Application by Vattenfall Wind Power Limited for the Thanet Extension Offshore Wind Farm Development Consent Order

The Examining Authority's second written questions and requests for information (ExQ2)

Issued on 10 April 2019

Extract from Onshore Land Plans Sheet 2 [REP2-011].
Excluded land highlighted in purple polygon.

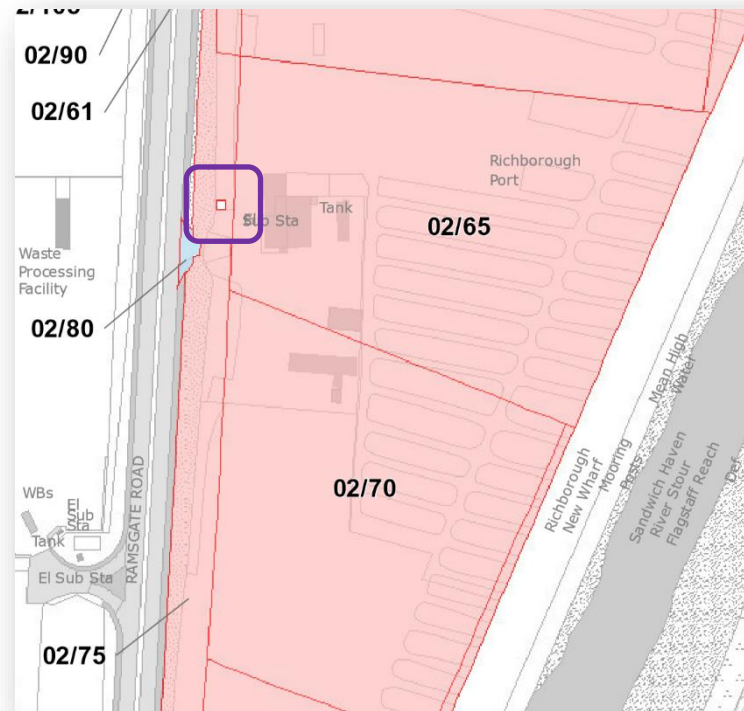
2.1.5.	The Applicant and Ramac	<p>Excluded Land: Parcel 02/75 The Onshore Land Plans identify a small plot of land excluded from the CA request for permanent freehold acquisition on Parcel 02/75.</p> <ul style="list-style-type: none"> a) Can the Applicant please explain the purpose for which this land has been excluded. If the exclusion is in error can the Onshore Land Plans be replaced at Deadline 5. b) Can Ramac please review the Applicant's response to this question at Deadline 5 and if the exclusion is intentional, please identify what effect the exclusion of this land from CA will have on Ramac <p>{See Land Plans extract identifying the plot}</p>
